GOVERNMENT OF THE DISTRICT OF COLUMBIA
OFFICE OF PLANNING

MEMORANDUM

SUBJECT: **BZA Application No. 17360-** Request filed by Henderson L. Walker for a special exception to permit the construction of a group of flats at 1270-1280 Talbert Street, S.E., proposed by Yosief Maharai.

SUBJECT: Review Comments on BZA Application No. 17360, 1270-1280 Talbert Street, S.E.

SITE PLAN

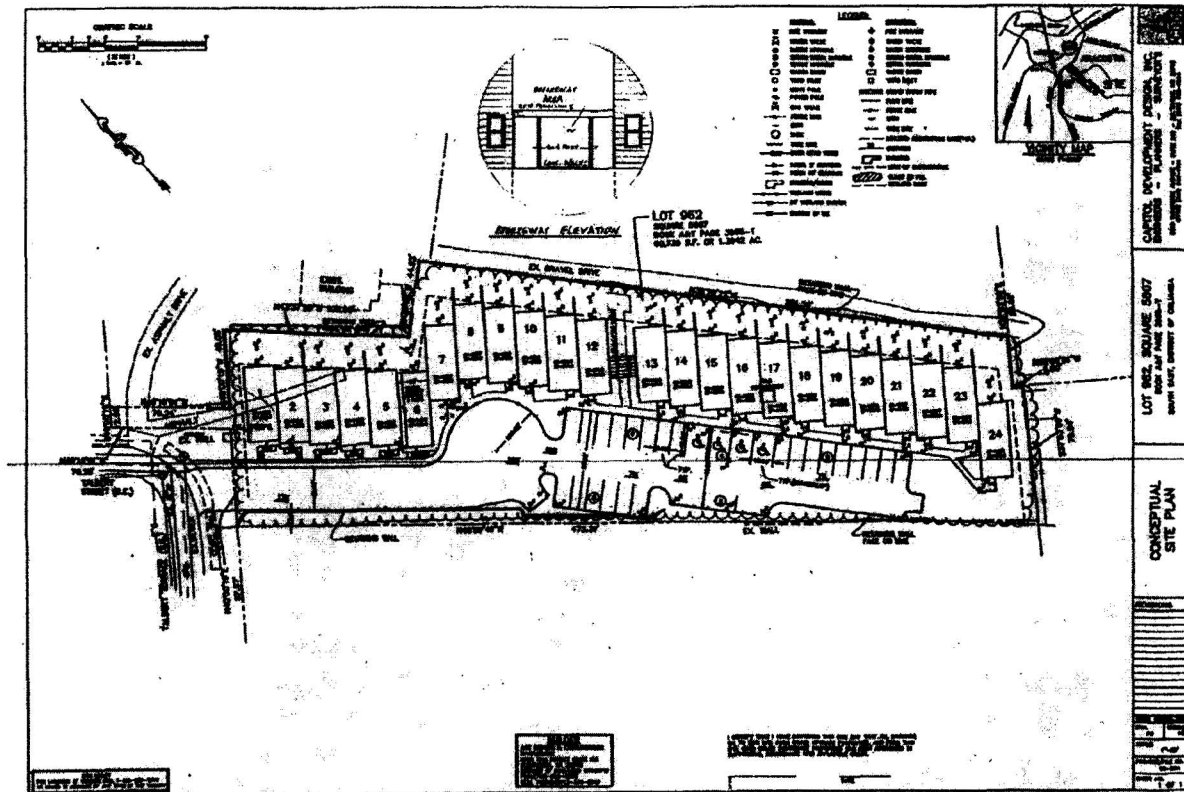
The front entrances do not abut a street, front yard or front court. Section 2516.5(b) requires a 20-foot open space to the front of each entrance that would satisfy this criterion. However, it is not provided for on the site plan.

As proposed, none of the front entrances face a street, front yard or front court, but instead face either a private drive or a parking lot. Section 2516.5(b) requires a 20-foot open space to the front of each entrance, which is not provided for on the site plan.

The proposed site plan does not provide for an area between the sidewalk and the front wall of the buildings, resulting in a much more severe appearance from the private drive and parking lot due to the lack almost anything but hardscape at the entrances to the dwellings. The erection of the buildings as proposed would adversely affect the present character and future development of the neighborhood because of the layout of the site. Therefore, the Office of Planning recommends that the applicant comply with all of the provisions of Section 410 to ensure that proposed development does not adversely affect the present character and future development of the neighborhood.

The applicant has submitted grading and landscaping plans. The landscaping plan provides trees at the entrance and along a portion of the parking lot, but nowhere else. No foundation plantings are proposed to the front of the structures. The Office of Planning recommends that shade trees be provided to the rear of the structures, and ornamental trees and foundation plantings in the form of shrubbery to the front.

The subject application is not in conformance with this criterion. Although the principal buildings have no street frontage, the site plan does not divide the lot into theoretical lots. All of the front entrances face the drive and parking lot, making the front of each building the side that faces the drive and parking lot.

The minimum front open space requirement of 20 feet, equal to the rear yard requirement within the R-4 Zone District, is not provided. Not only does the proposed site plan not depict this open space, but also it proposes either common parking within a parking lot or the private drive within that area. A minimum of one parking space needs to be delineated on each theoretical lot improved with a flat, which is not provided for by the application.

FEMS has informed the Office of Planning that rear vehicular access is required. The site plan fails to provide this. The applicant has proposed a second fire hydrant to the rear of the structures. FEMS informed the Office of Planning by telephone that although the second fire hydrant helps, it does not alleviate the problem.
